# 5 Year Review Panel Questions – Day 1

## NSTX-U Team

**NSTX-U 5 Year Plan Review**  
**LSB B318, PPPL**  
**May 21-23, 2013**

# Expect substantial joint research on advanced divertors

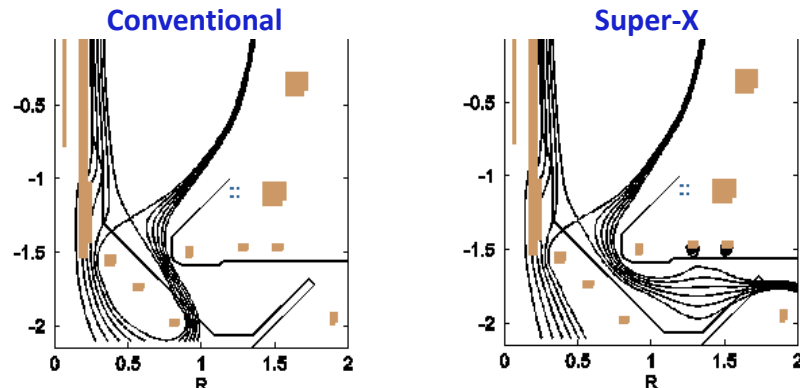
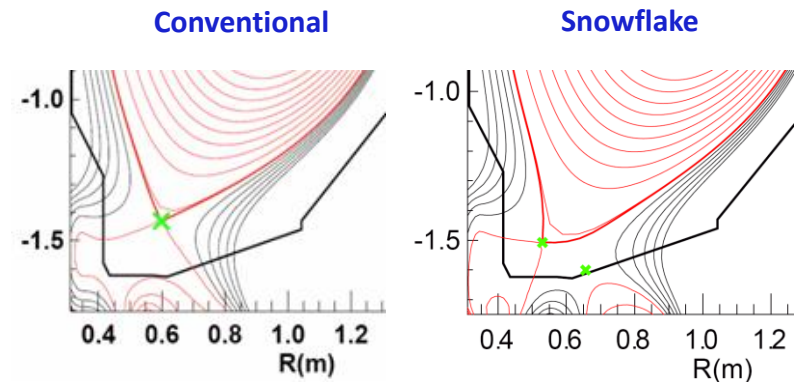
1. Compare and contrast the MAST and NSTX-U capabilities and plans
  - What are the complementary research objectives?
  - What sorts of plans for joint experiments exist?
  - What are possibilities for confirmatory experiments?
  - Addressed by J. Menard
2. More detail is desired on the attempt to get to steady state without a CS.
  - How do you envision developing the transition from CHI to HHFW to NBCD?
  - How do things fit together to inform FNSF after the end of 5-year plan?
  - R. Raman covered first question in his presentation
  - Informing FNSF: Addressed by J. Menard
3. What are your priorities that are for the upgrades included in the base program? Addressed by J. Menard
4. Please provide the FTEs for scientific staff, including collaborators
  - Addressed by M. Ono

- **MAST-U: Super-X + cryos**
- **NSTX-U: snowflake + lithium**
- Both will access high flux expansion, variation of line-length, pumping
- Complementary: open vs. closed divertor, different pumping techniques
- Both will require advanced boundary control
  - **Example: control of multiple X-points/flux expansion**
- Divertor requirements and optimization are critical issues for FNSF

Example Year 1 Scenario at 1.5 MA and 0.75 T

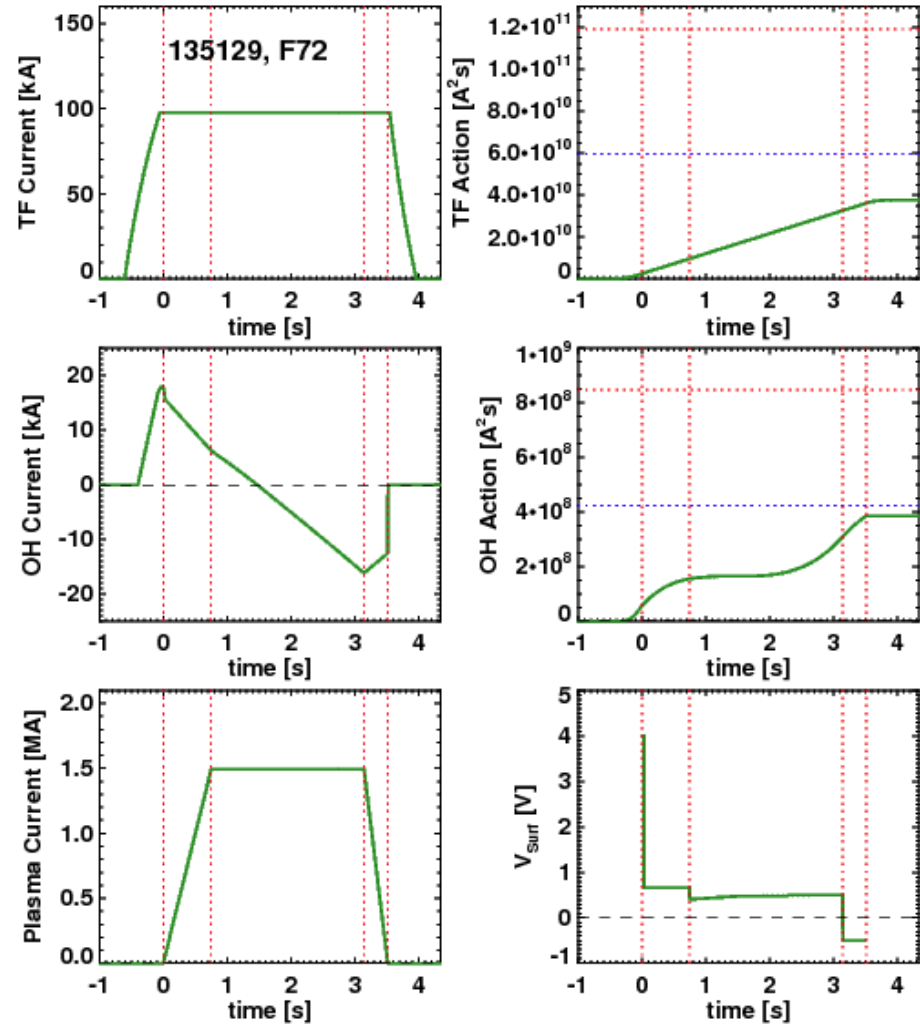
5. What are the rep-rate limitations for high field operation?
  - What arises first, second, third?
  - How do you plan deal with them?
  - Addressed by S. Gerhardt

- Use OH pre-charge that causes the OH coils to maximize the time near zero.

- Proper pre-charge will be a function of the target plasma current and non-inductive level.
- In general, OH heating likely to provide pulse duration constraint in year 1 of NSTX-U (limiting heating to  $\frac{1}{2}$  the design point).

- For year 1 example with 19 kA pre-charge with  $I_{RMS}=0.9$  kA (1200 sec configuration), OH rep rate is 9 minutes.

- TF cools in 15 minutes for this case.
- Even most aggressive year 1 scenarios will not have cycle times longer than NSTX standards.

# Semi-analytic pumping model used to optimize plenum geometry

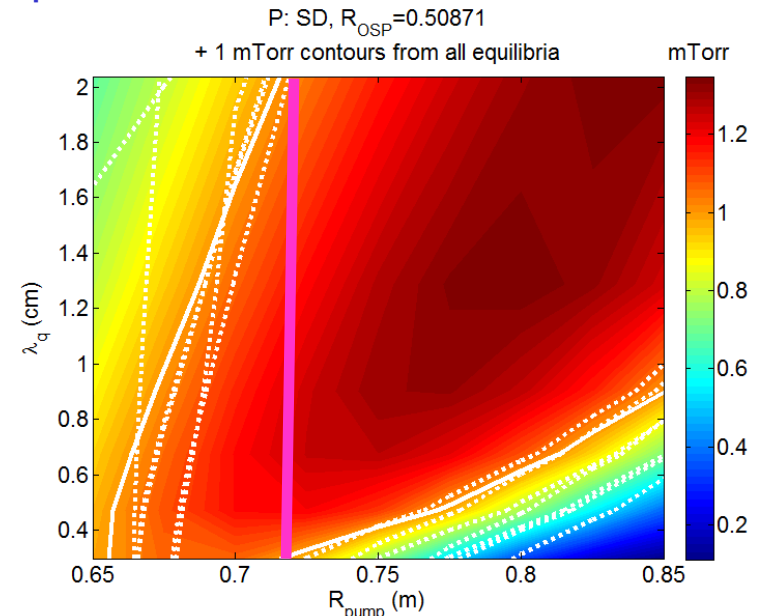
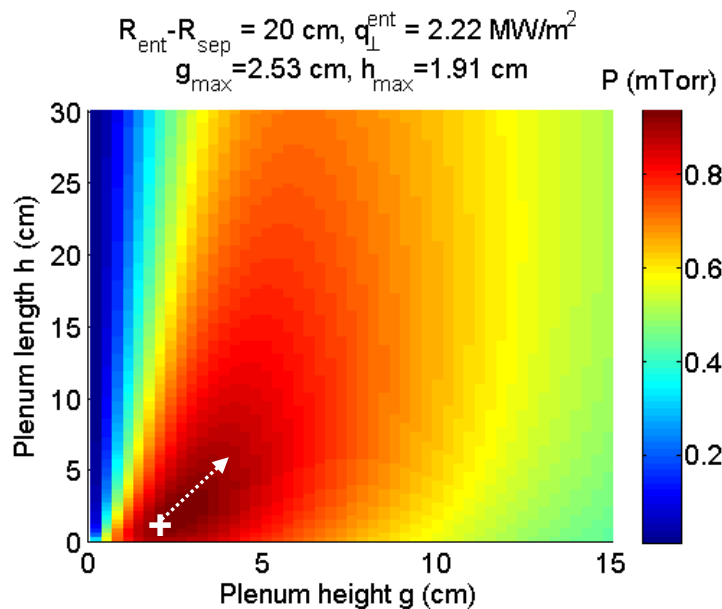
6. What is the physics basis for the cryopump and the expected particle exhaust rates as compared to lithium coatings?
  - Addressed by J. Canik

- Model developed for DIII-D pumping studies (Maingi, NF '99)
  - Predicts plenum pressure, validated with DIII-D data
  - Projected NSTX-U heat flux ( $I_p$  scaling) and divertor  $T_e$  ( $\sim 15$  eV) used as input
  - Uses first-flight neutral model (insufficient for detached divertor)
- Pressure is maximum for duct height  $g \sim 2.5$  cm, length  $h \sim 2$  cm
  - But is only weakly reduced if these are increased together
- With pump entrance at  $R=0.72$ m, pressures  $>1$  mTorr can be reached over wide range of plasma shapes and SOL widths
  - Comparable to pressures in DIII-D plenum
  - Well above that needed to pump NBI particle input
